2.0 PROJECT DESCRIPTION COMMENTS AND RESPONSES

STATELINE RETAIL CENTER

Figure 2-6: Proposed Overall South Elevation
Stateline Retail Center
Town of Southeast, Putnam County, New York
Source: DCAK-MSA Architecture
Drawing Date: 11/25/08
Scale: As shown

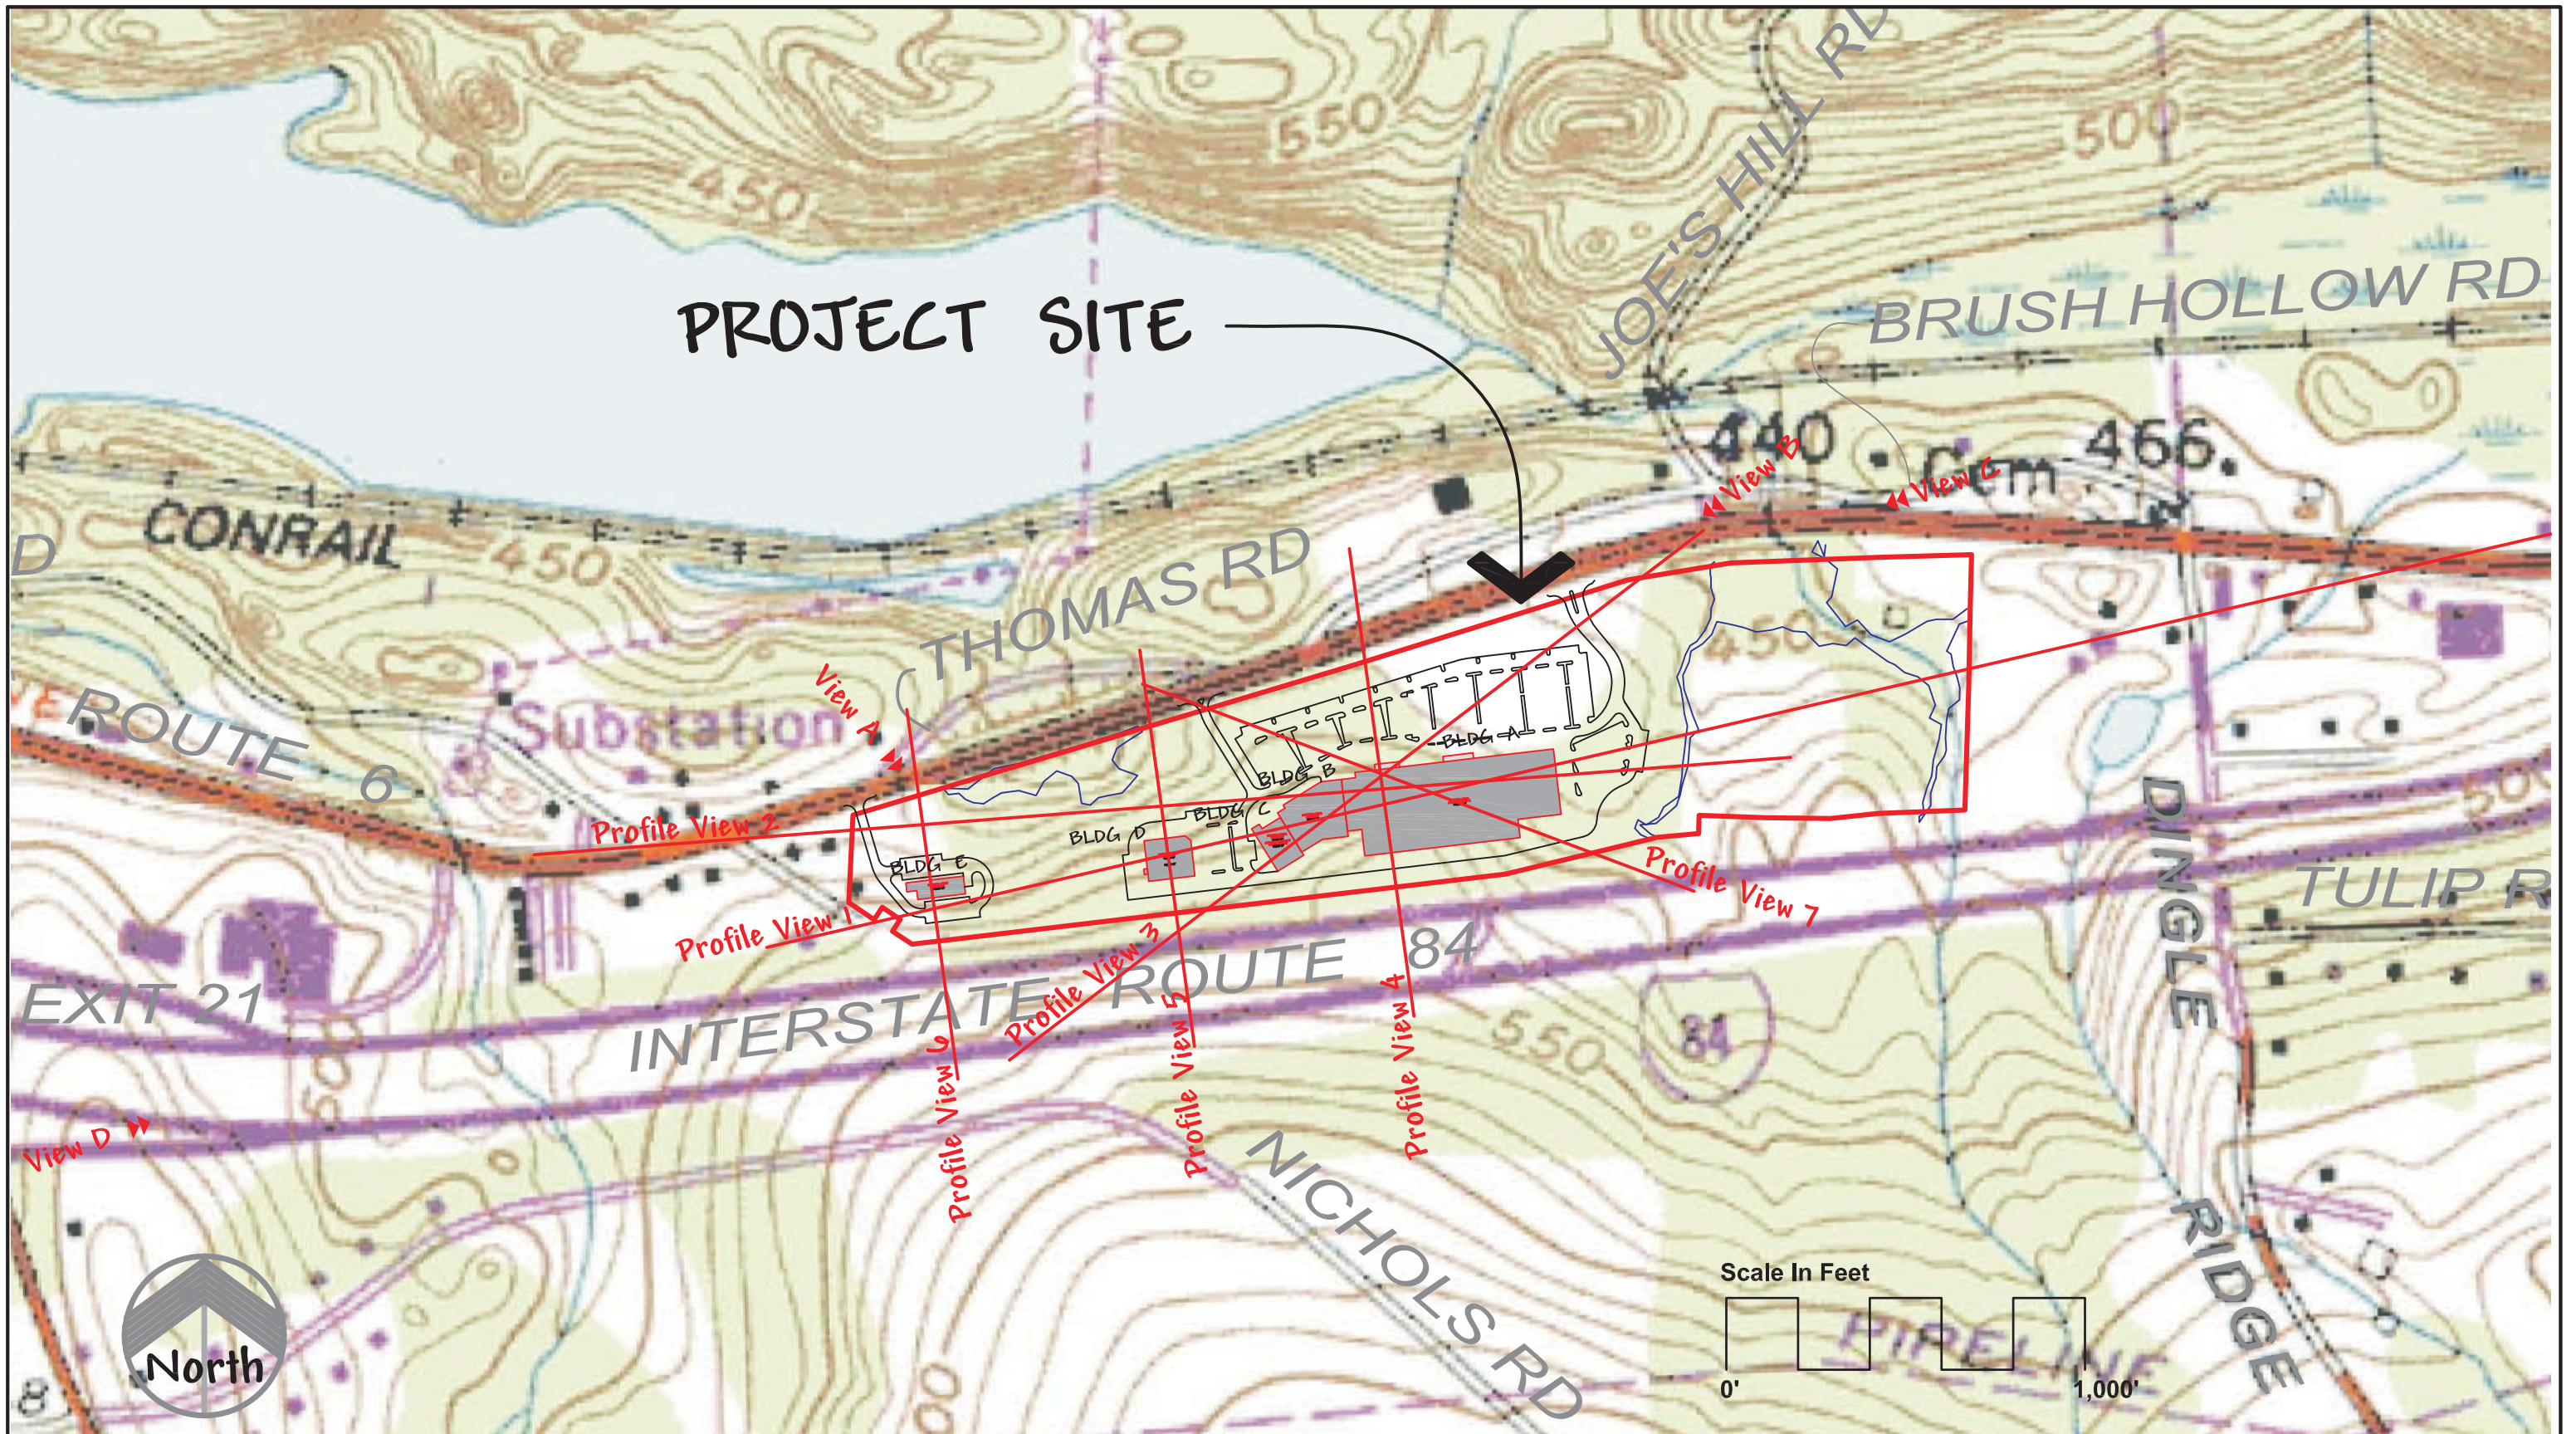
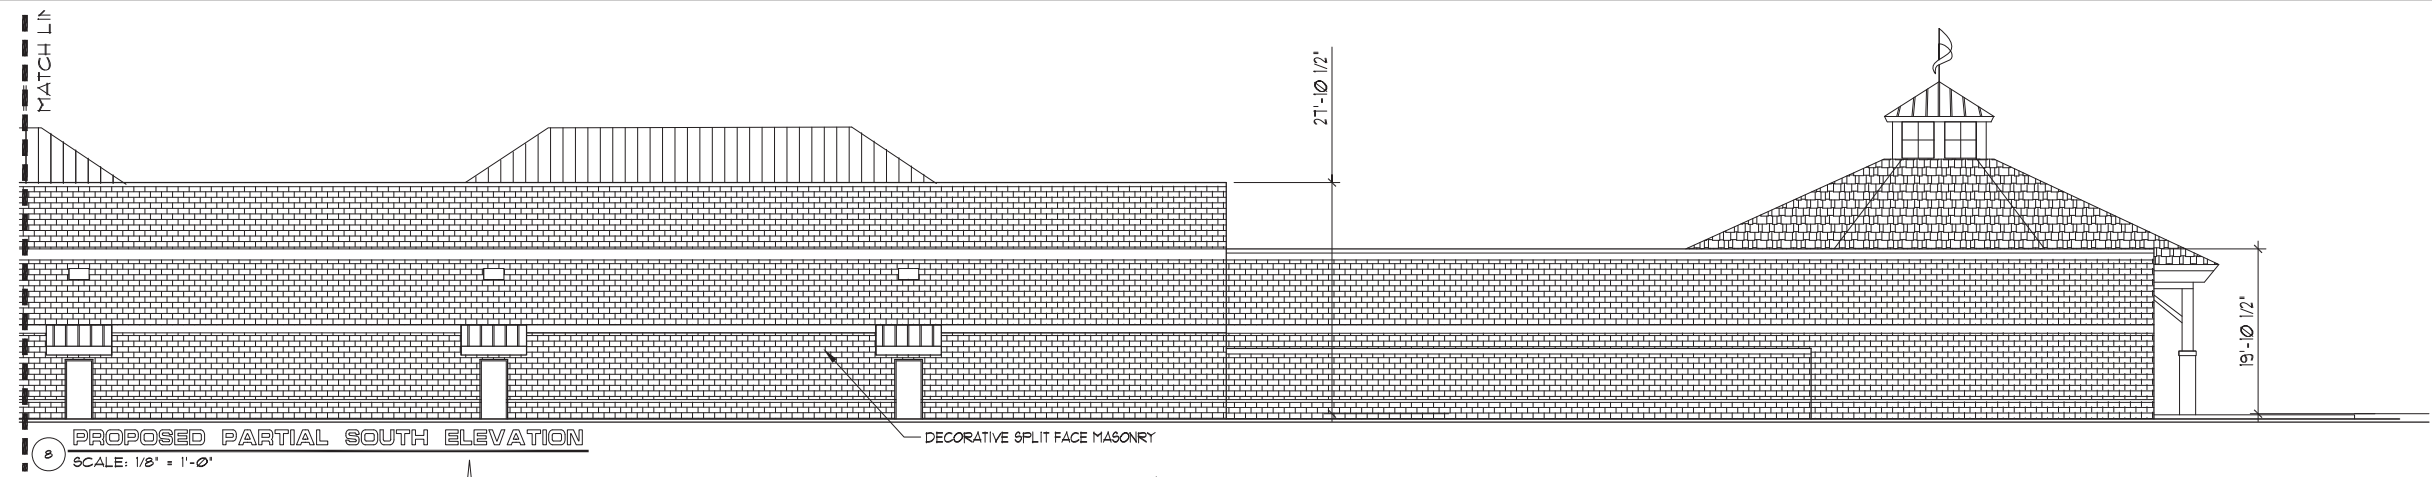
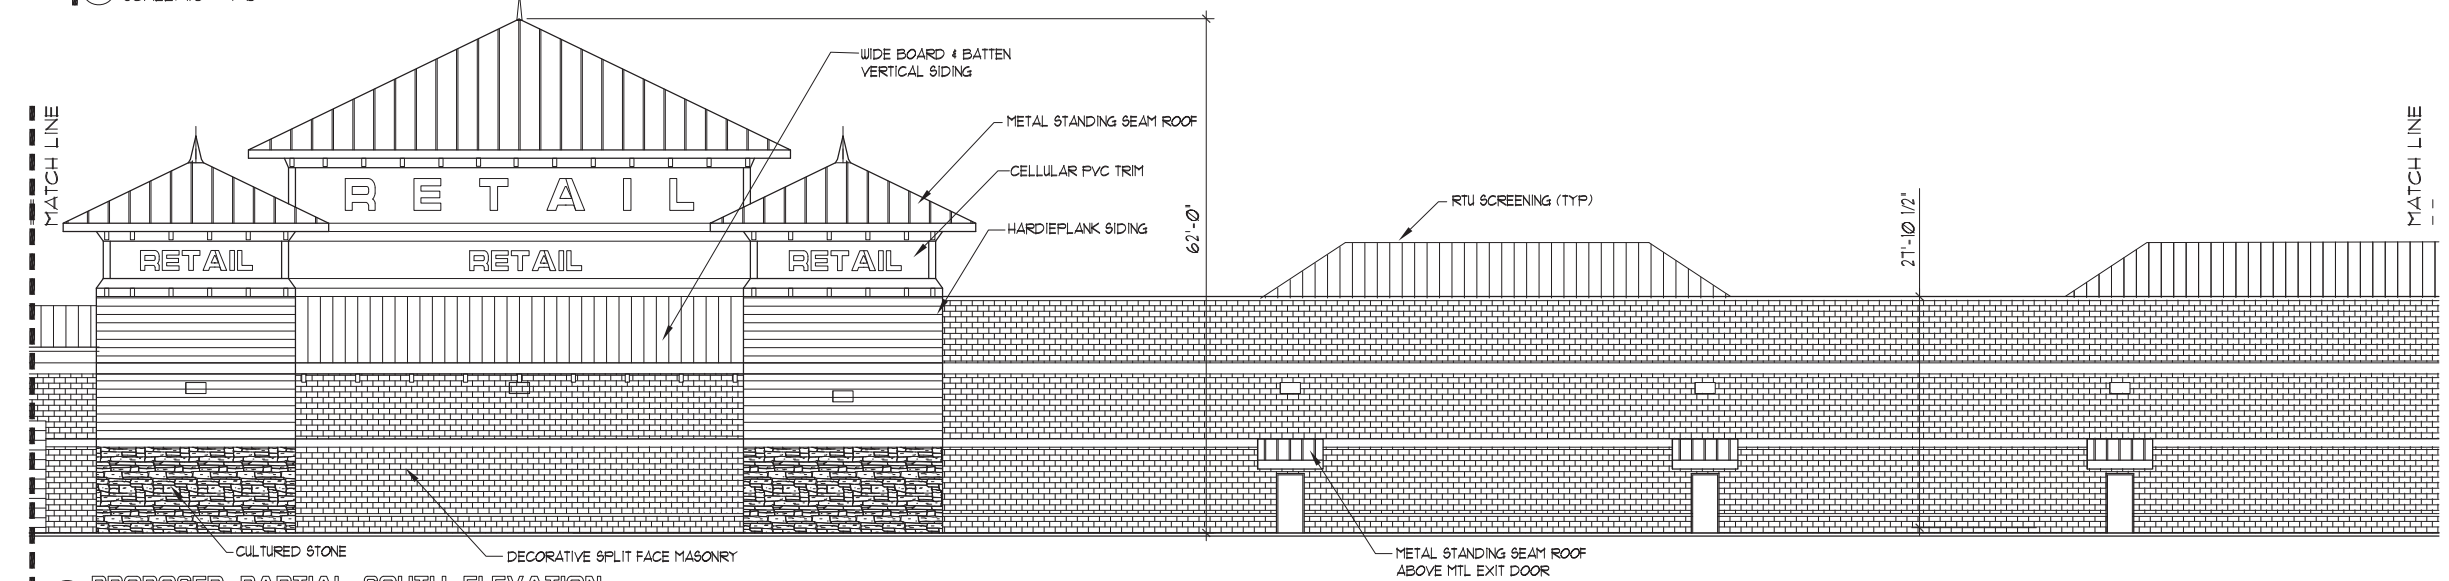
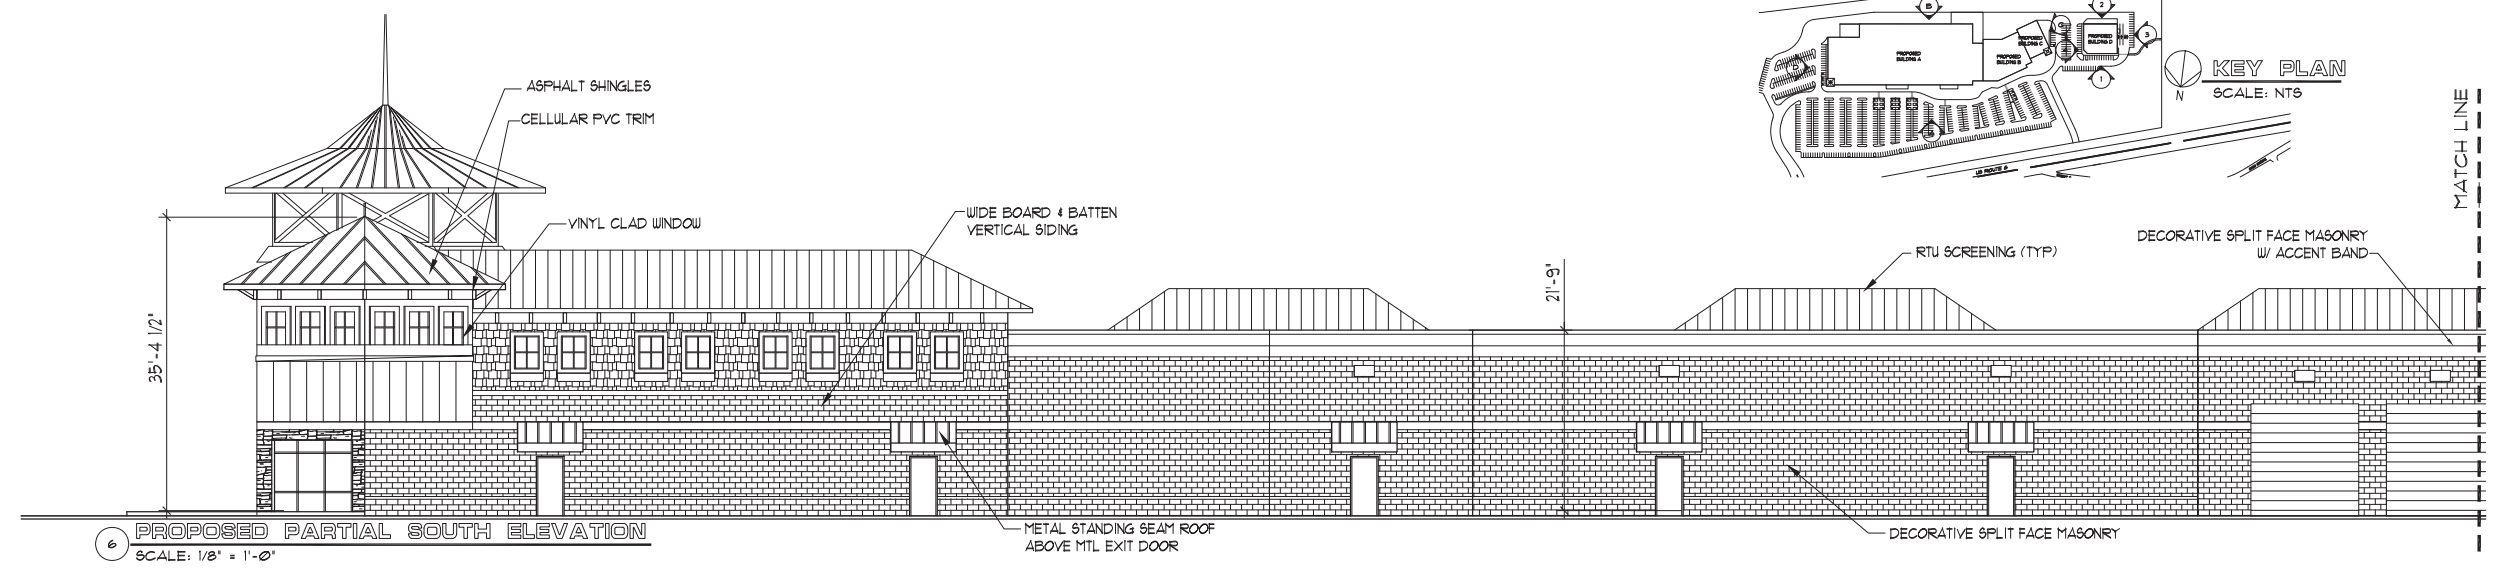
Comment 2.0-9 (Mr. Dan Armstrong, Public Hearing, July 14, 2008): How much latitude is in the overall design? How much [latitude] are they [the tenants] going to have? And that's assuming you don't have tenants when this gets approved. You know, Home Depot or Kohl's is another one where they have a design that they use all over the place, and they will modify slightly. But we're talking here about kind of putting a lot of time into it, into a whole series of elements that may not fit with their image of their store, the corporate image...I don't know how you're going to make all that work with a variety of tenants unless you're going to be able to negotiate with them and say this is it, take it or leave it, because from my understanding, whatever is approved as part of the DEIS or the final EIS, that's what's going to have to be built. This is what you're presenting now but your tenants or whatever, economics makes you, forces you to do something different. **[A similar comment was voiced by Ms. Lynne Eckhart, Public Hearing, August 11, 2008.]**

Comment 2.0-10 (Mr. Dan Armstrong, Public Hearing, July 14, 2008): My understanding is that the ordinance says that you must treat all facades with the same architectural treatment. So there has to be some kind of treatment of the facade that faces 84...you did show the side facade.

Response 2.0-9: The modified plan includes a variety of architectural elements that will be incorporated throughout the proposed development; refer to Figures 2-3, 2-4, 2-5,

2-6 and the drawings contained in Appendix D herein for a complete set of building elevations developed by the project architect. Similar to any other Town requirement, the architectural features will be an enforceable element of the project through the new zoning law and conditions set forth in the special permit (Section 138-63.4 of the Town Code).

Refer to Figures 2-7, 2-8, 2-9, 2-10 and 2-11 (originally presented in the DEIS) and Figure 2-2 for a series of sight-line drawings into the project site from various vantage points along Interstate 84. The three dimensional animation contained in Appendix C and offered on the Town website provides views of the developed project from the perspective of vehicle occupants traveling both east and west on Interstate 84. Due to the limited visibility into the site from the highway, motorists will not see the rear of the proposed buildings. Nonetheless, while not as articulated as the front, the Applicant and the project architect have included architectural treatments including towers, columns, standing seam metal roofs and a variety of building materials and colors, for employees and delivery vehicle drivers who will travel to the rear of the buildings. Note, patron parking and traffic are not proposed for the rear of the building. Figures 2-3 and 2-6 depict views of the rear of these buildings.
